Private Fuel Storage, L.L.C.

**SUPPLEMENTAL RESPONSE TO RAIs
PRIVATE FUEL STORAGE FACILITY
DOCKET NO. 72-22 / TAC NO. L22462
PRIVATE FUEL STORAGE L.L.C.**

SAR CHAPTER 2 - SITE CHARACTERISTICS

REQUEST FOR ADDITIONAL INFORMATION NO. 1
QUESTION 2-3
WATER WELLS WITHIN 5 MILES (8 KM)
OF PFSF SITE
PRIVATE FUEL STORAGE FACILITY

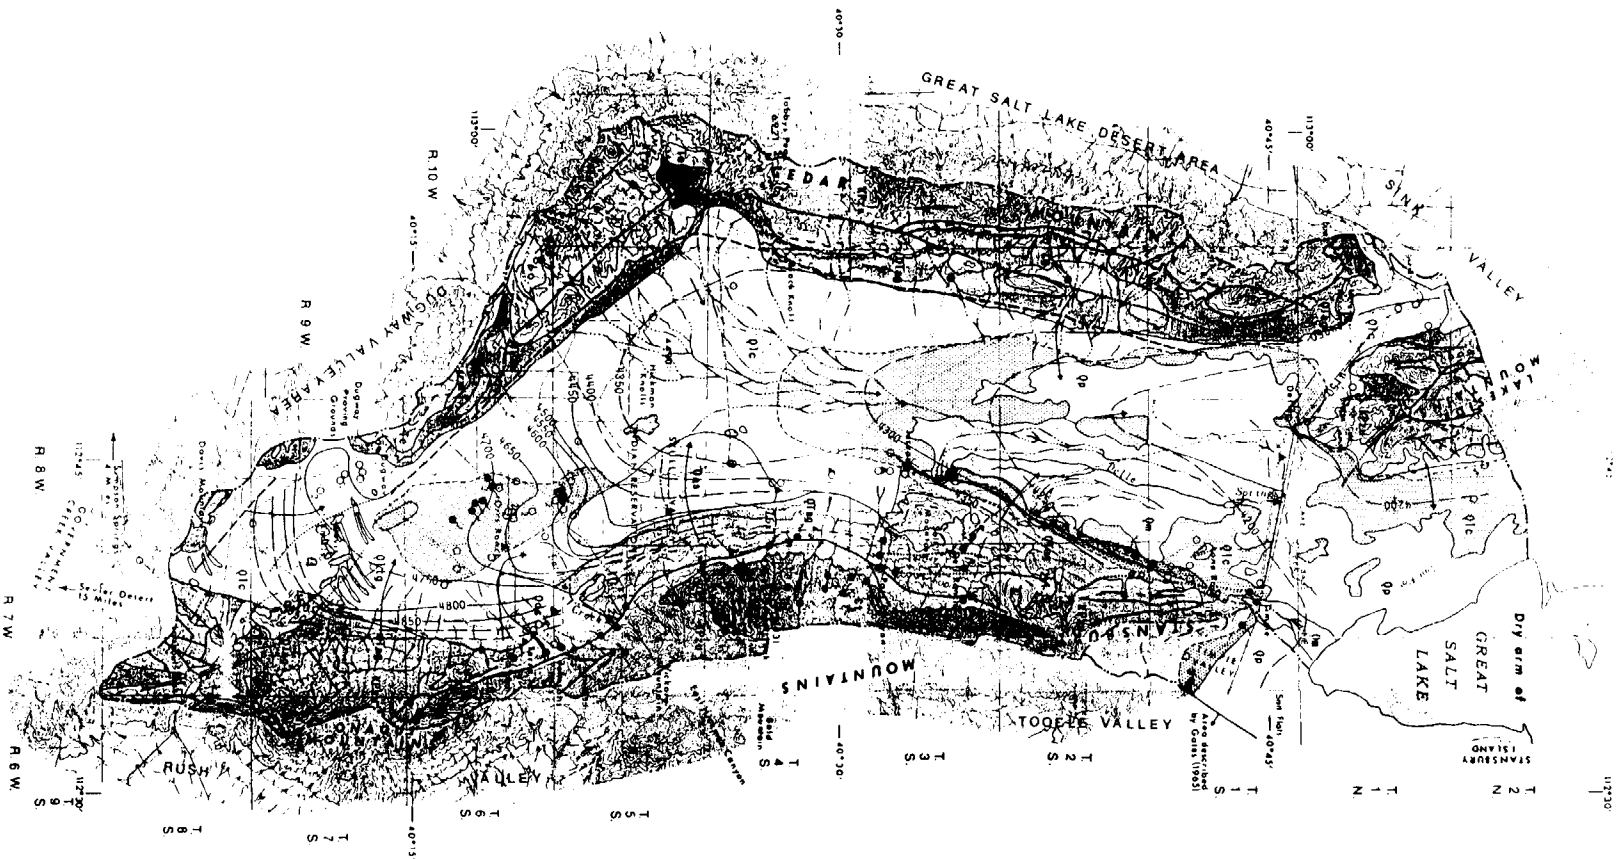
- 2-3 Provide the following information relative to the withdrawal and use of water on or near the proposed Private Fuel Storage Facility (PFSF):
- (a) A map that shows where water withdrawal is occurring on or in the vicinity of the PFSF site with particular reference to the proposed storage pad. At the least, include all wells located within a minimum 8-km (5 mi) radius of the PFSF.

- (b) For each identified well-
 - Depth to water
 - Formation from which water is withdrawn
 - Quantity of water withdrawn annually and pumping rates
 - Discussion of use of the water from each well with particular reference to any consumption by humans or animals

- (c) If no water wells are located within the specified 8-km radius of the proposed PFSF site, include a specific statement such as "No groundwater is extracted within the 8-km (5 mi) radius of the proposed PFSF."

- (a) The enclosed figure indicates the locations of all known water wells within 5 miles (8 km) of the PFSF. Other off-Reservation wells may have been drilled within five miles of the PFSF but they do not have a current water right on-file with the State's Division of Water Rights. Some of the wells in the table appear to be abandoned or have not been utilized in many years, such as the wells to the west and south of the Reservation, but the water right has been maintained.
- (b) The enclosed figure includes a table listing the requested information, where available. No crops for human consumption are grown with water from irrigation wells listed in the table.

Plate 1. — GENERALIZED GEOHYDROLOGIC MAP OF SKULL VALLEY, TOOELE COUNTY, UTAH

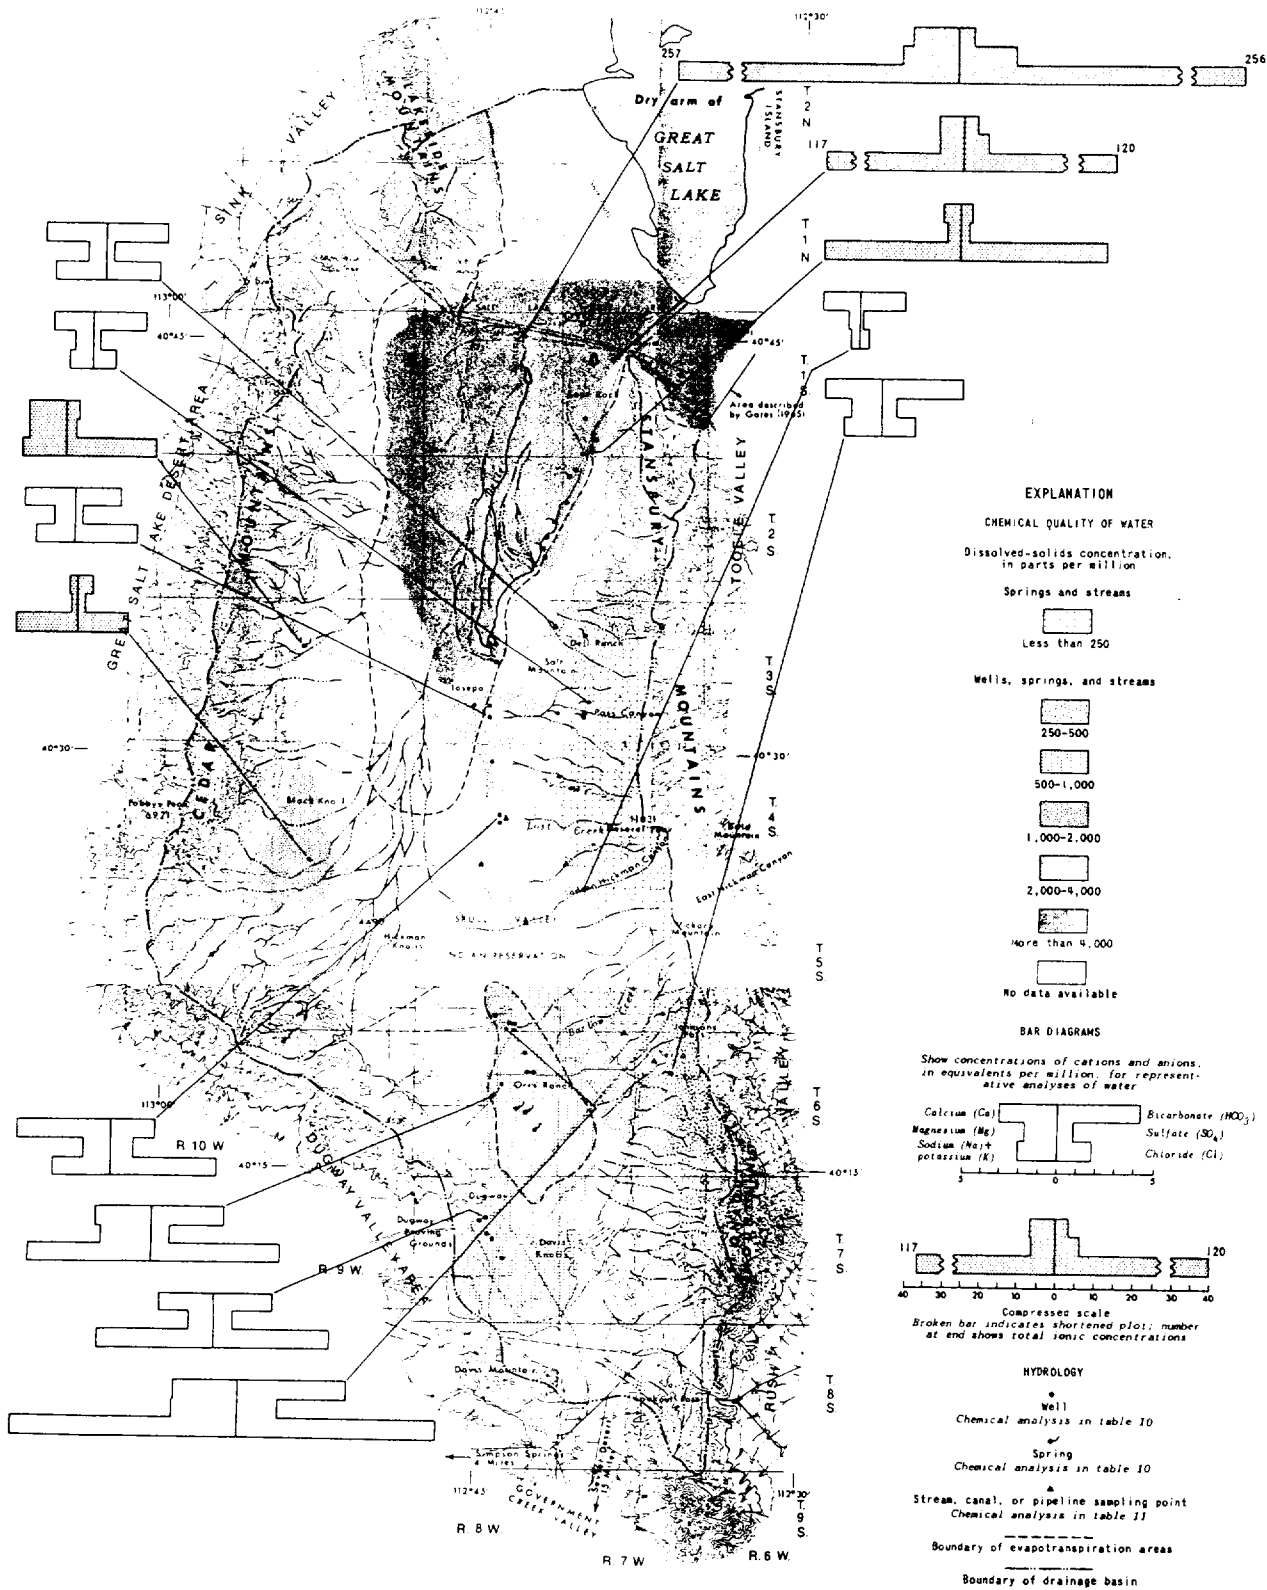
- (d) Potentiometric contours of groundwater at and around the proposed PFSF site (if relevant).
 - (e) Classification of the aquifer beneath the PFSF site based on class of use and water quality (if relevant).

- (c) See response to (a), above.
- (d) The potentiometric map (Plate 1) from Hood and Waddell is included as part of this response.
- (e) The State has not applied an aquifer classification system to the aquifer in Skull Valley. A water quality map (Plate 2) from Hood and Waddell is included as part of this response.
